FED. ROAD DIST. NO.	STATE	FED. AID PROJ. NO.	FISCAL YEAR	SHEET NO.	TOTAL SHEETS
HAWAII	HAW.	BR-STP-056-1(35)	2000	C.O. 17	70

WAIKAEA BRIDGE WIDENING

KUHIO HIGHWAY-WAIKAEA BRIDGE WIDENING
Fed. Aid Proj. No. BR-STP-056-1(35)

LAYOUT PLAN

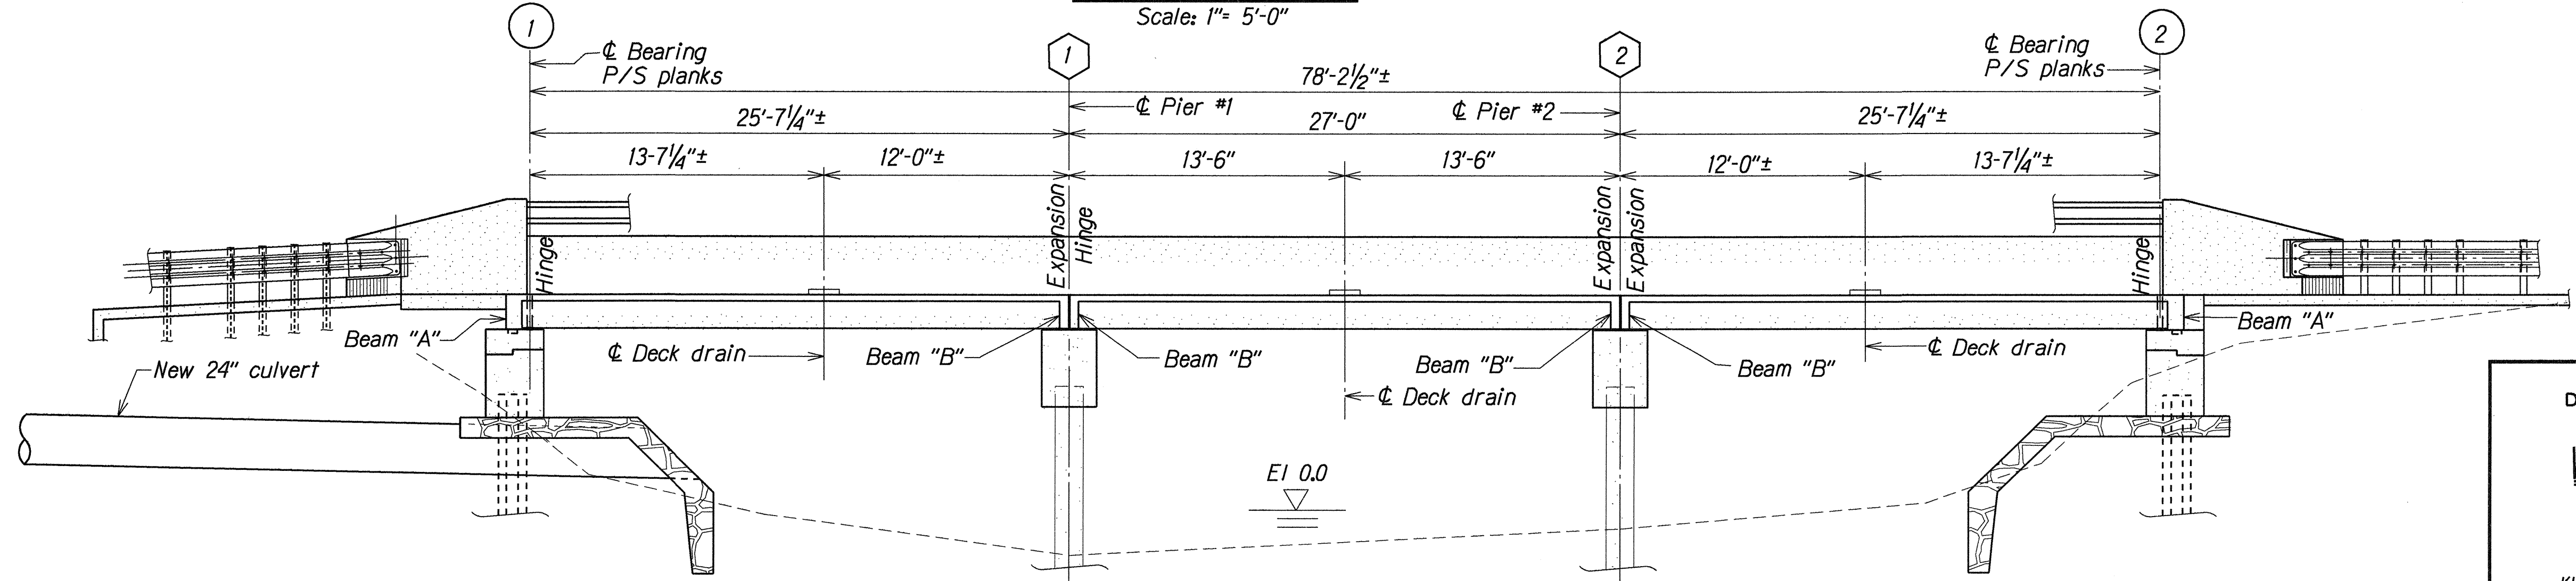
DATE	REVISION
3/15/01	Corrected sewer line location on Layout Plan.

STRUCTURE REMOVAL AT ABUT. #1 AND #2

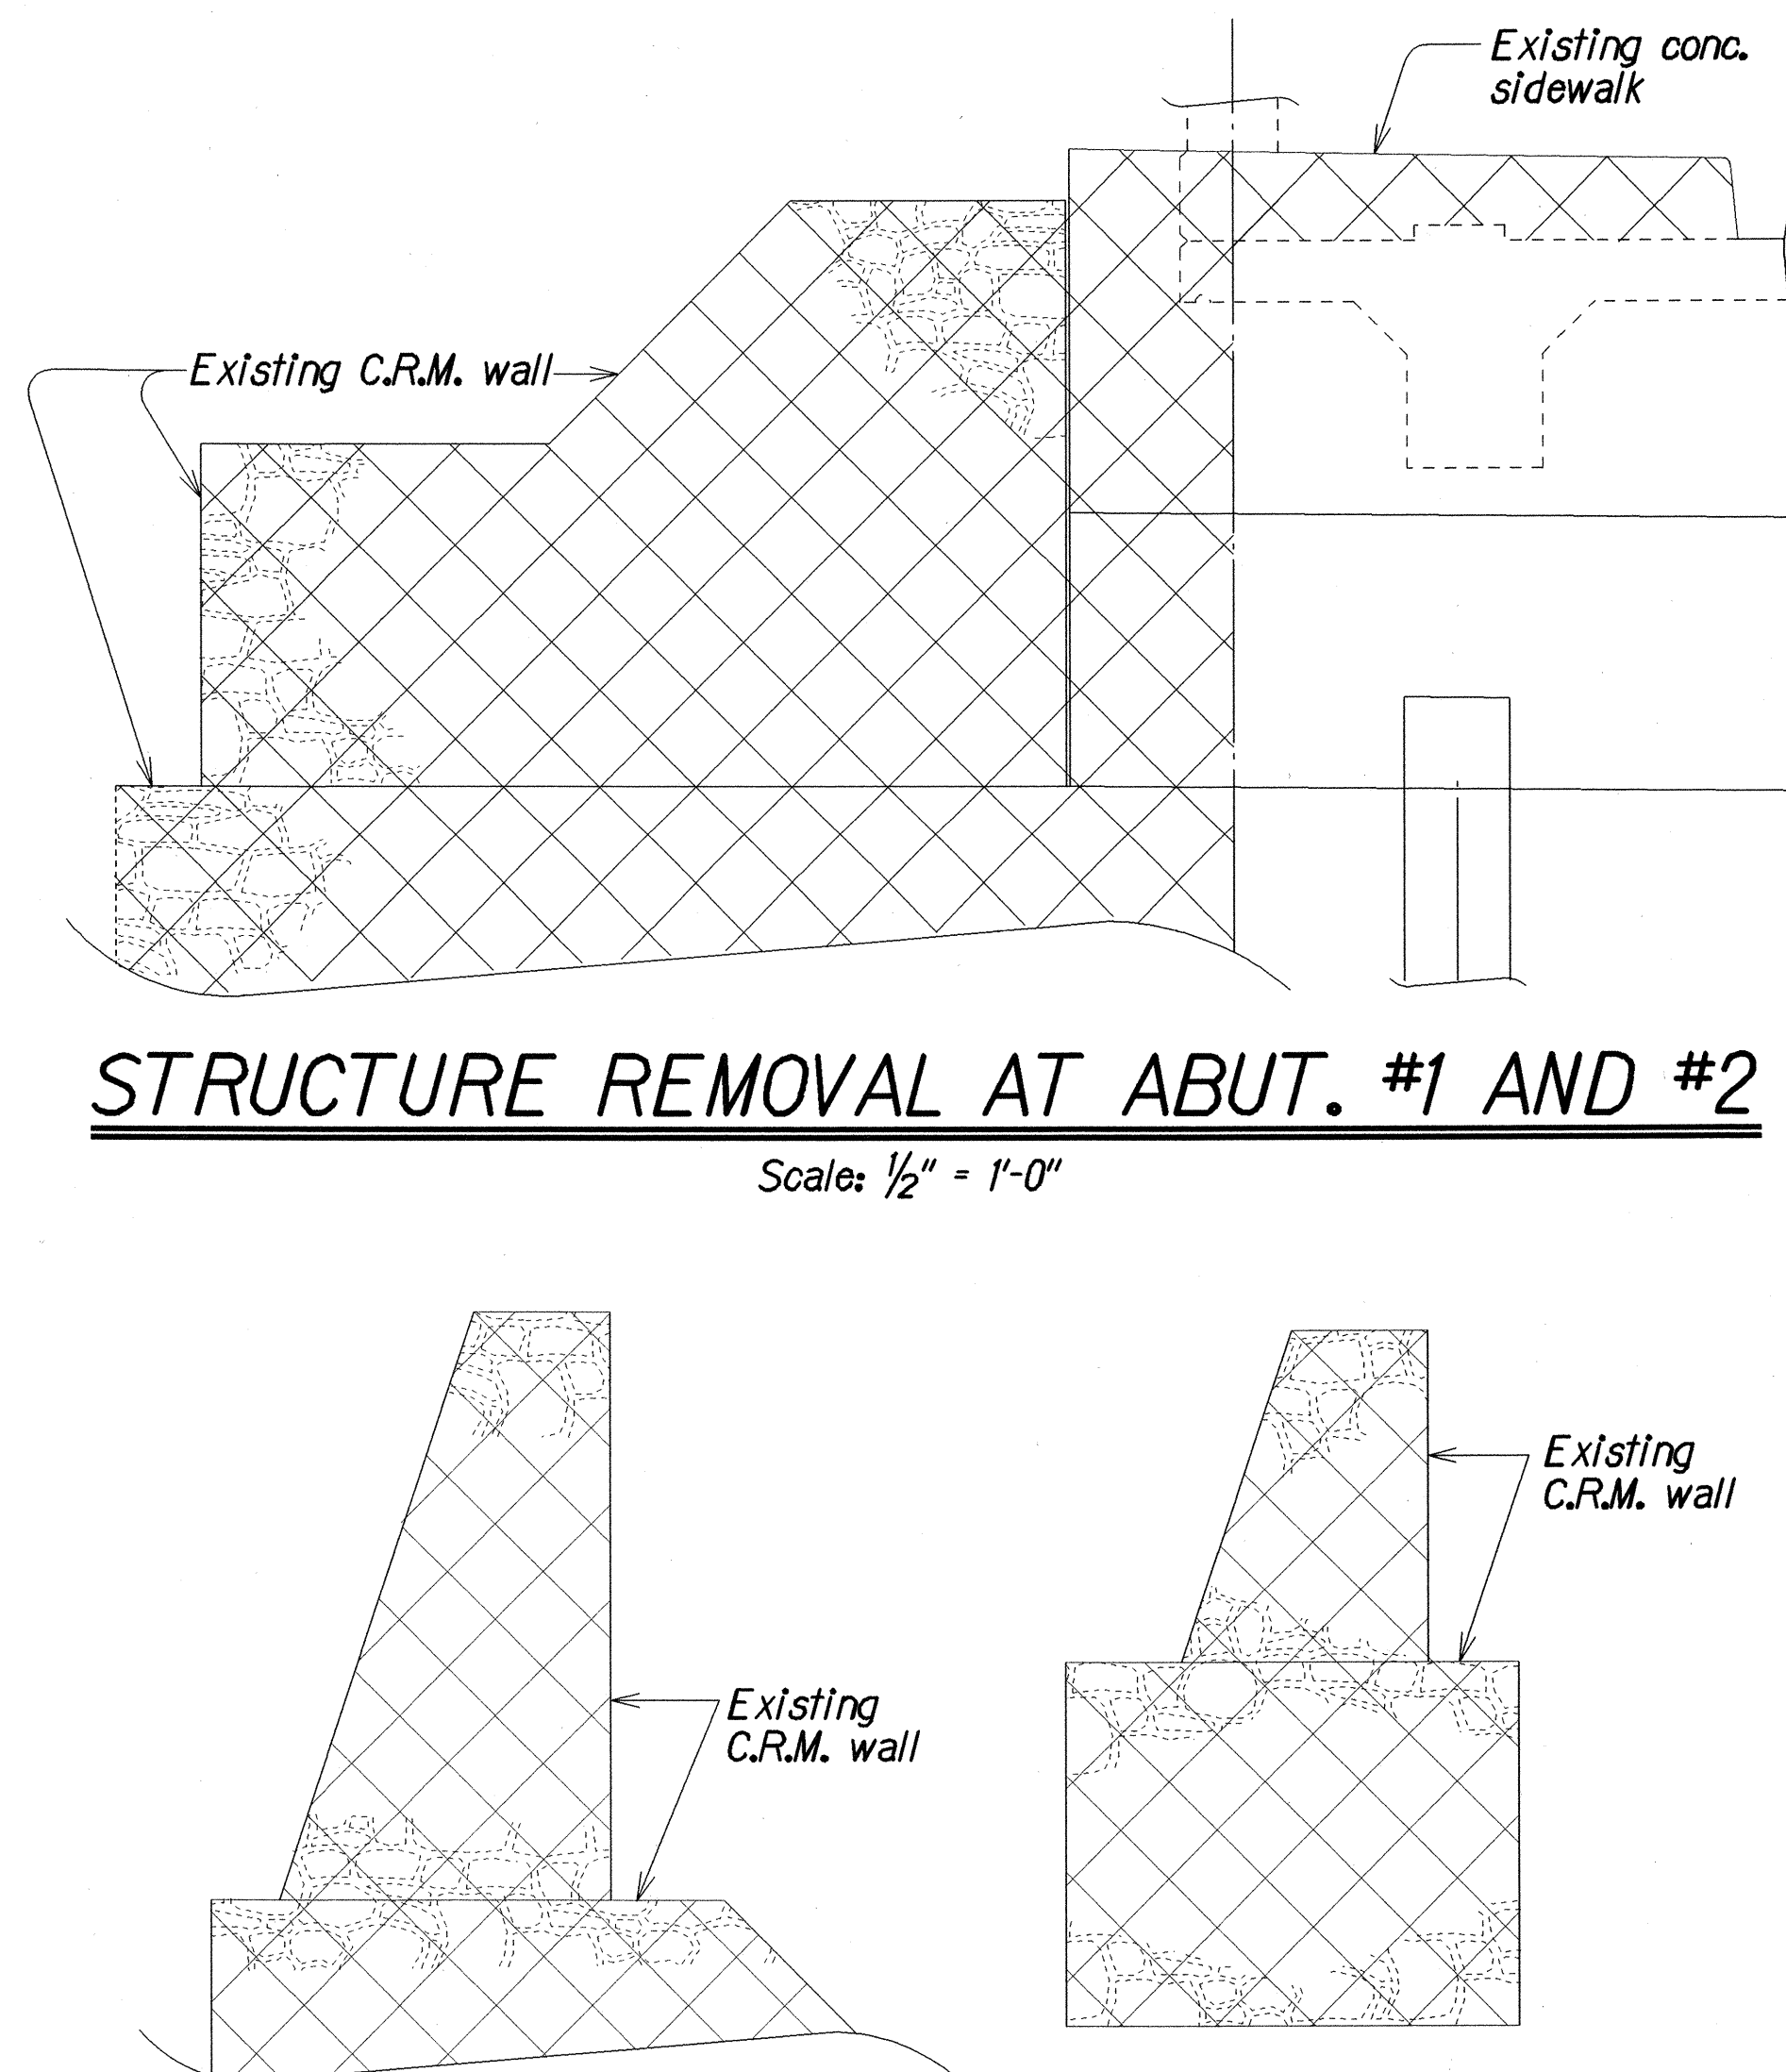
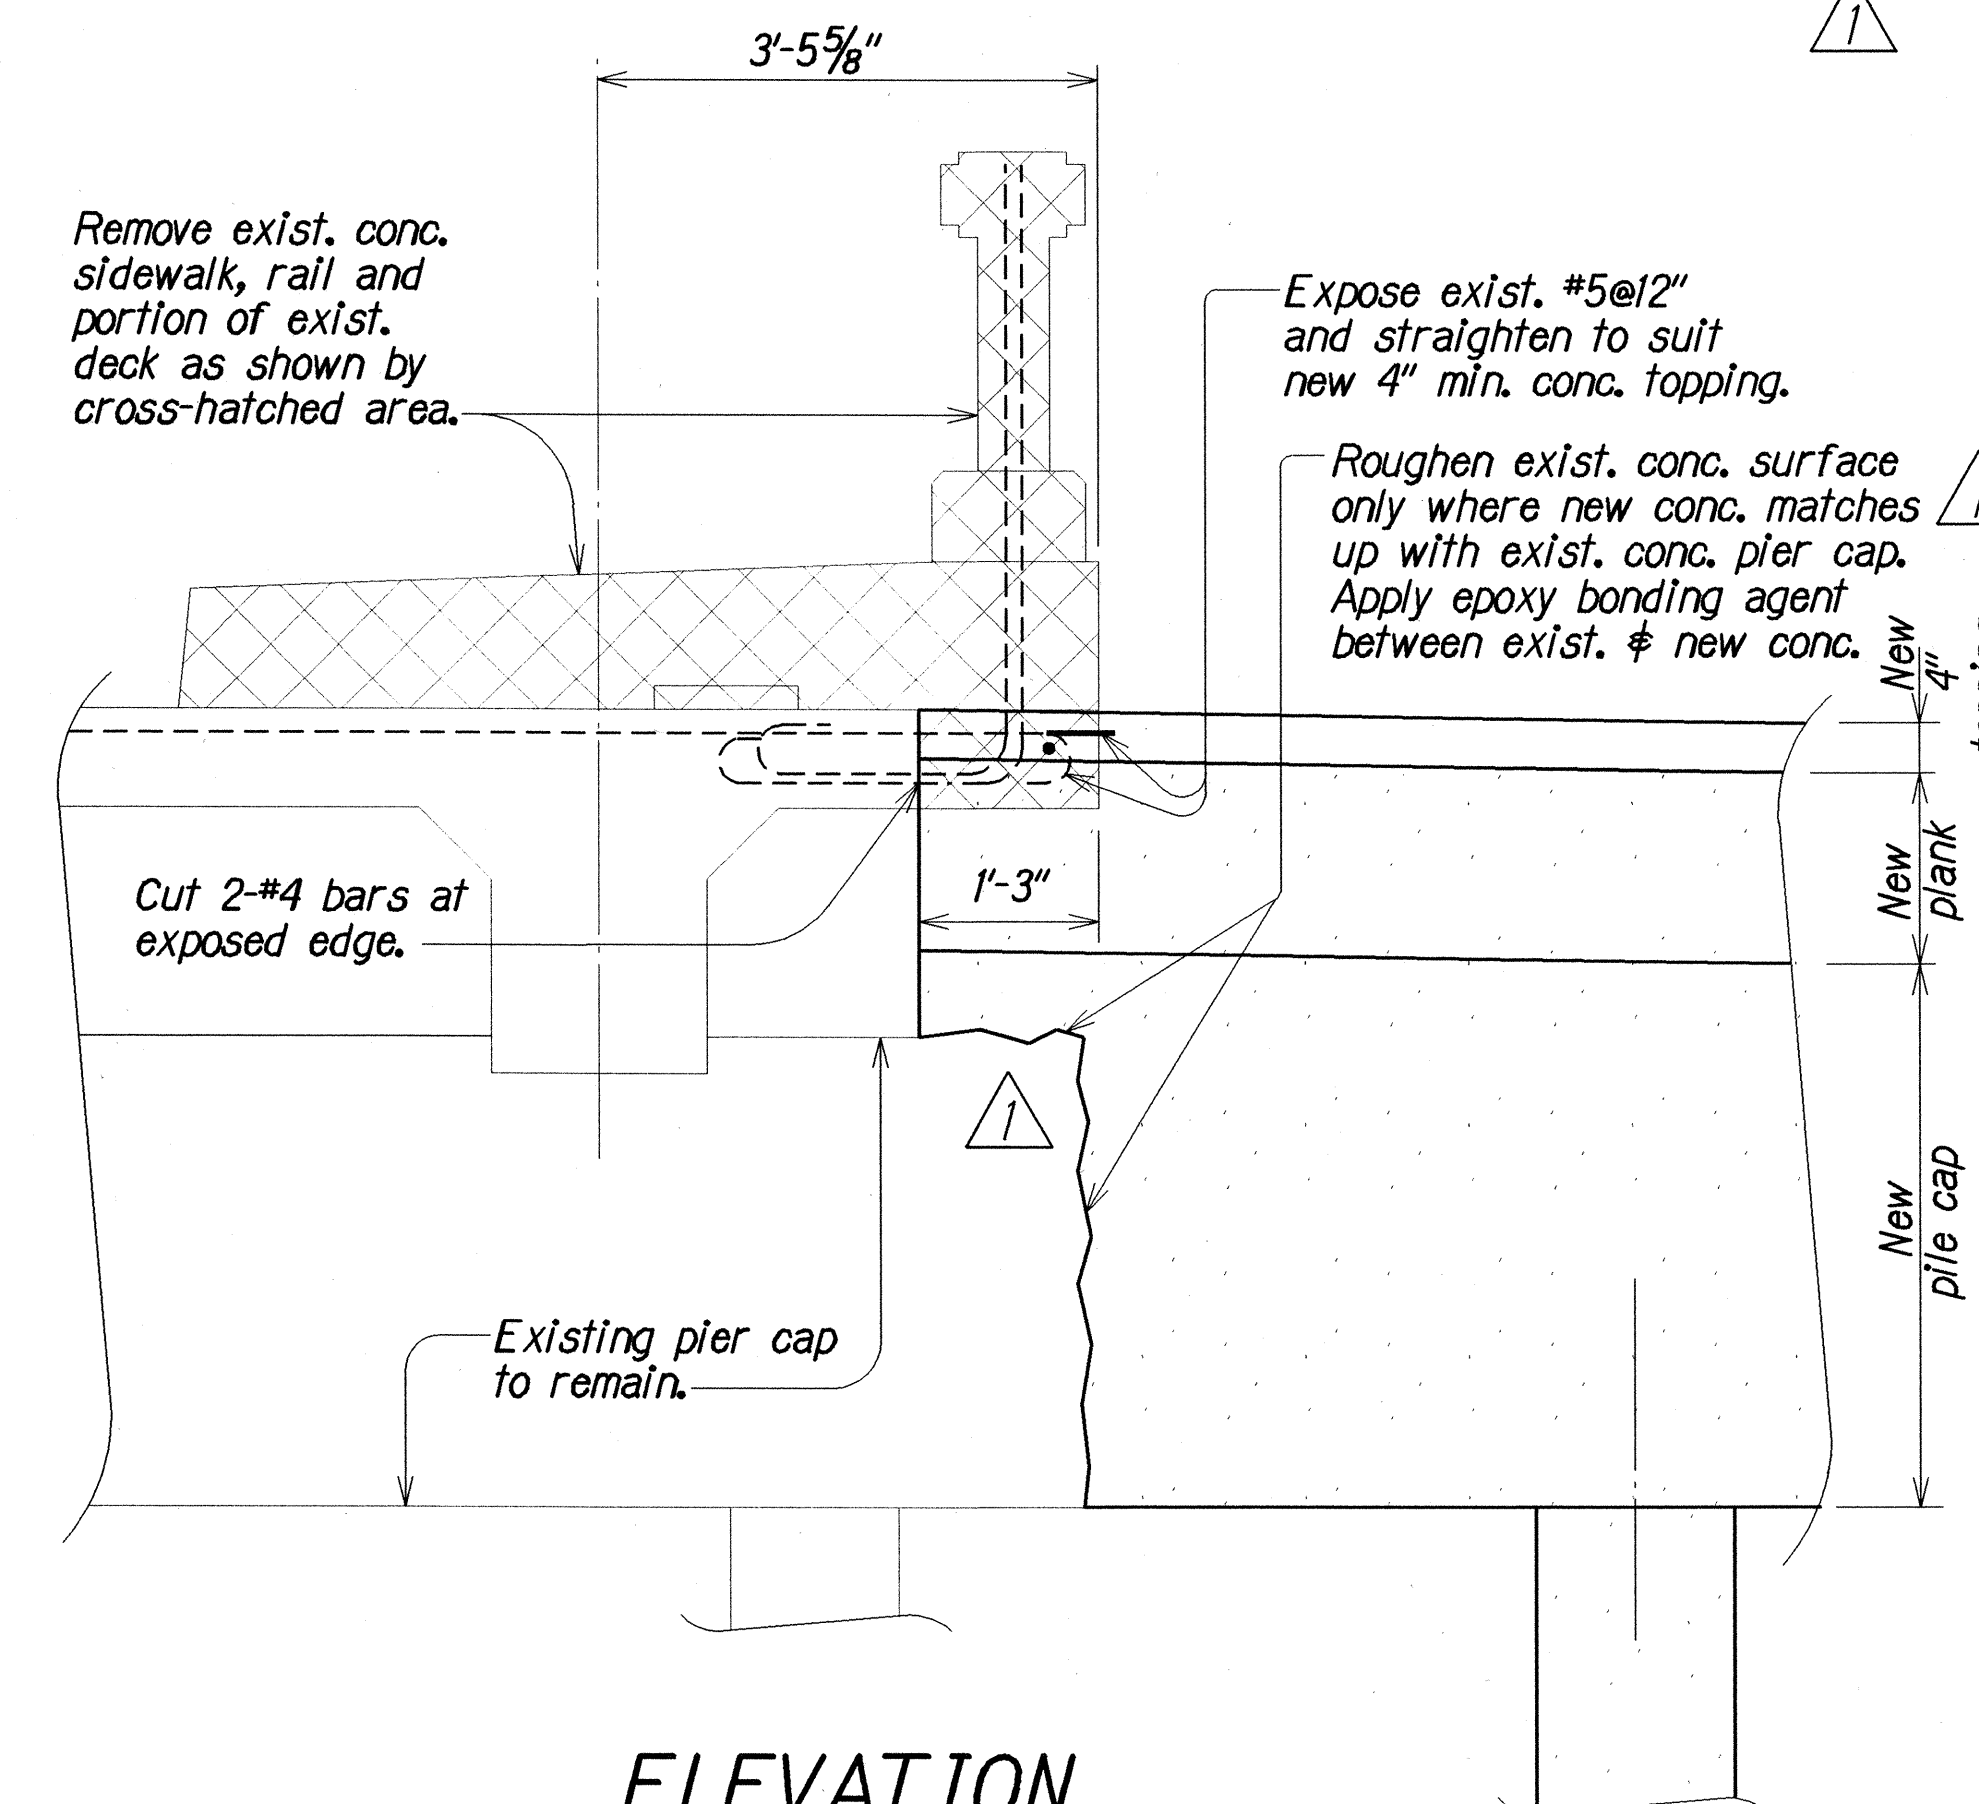
6/6/01	Added note to roughen exist. surface and to apply epoxy bonding agent between exist. and new conc. Label moved for clarity.
DATE	REVISION
STATE OF HAWAII DEPARTMENT OF TRANSPORTATION HIGHWAYS DIVISION WAIKAEA BRIDGE WIDENING STRUCTURE REMOVAL DETAILS AND BUILD-UP DETAILS KUHIO HIGHWAY-WAIKAEA BRIDGE WIDENING Fed. Aid Proj. No. BR-STP-056-1(35) Scale: As Noted Date: Aug, 1999
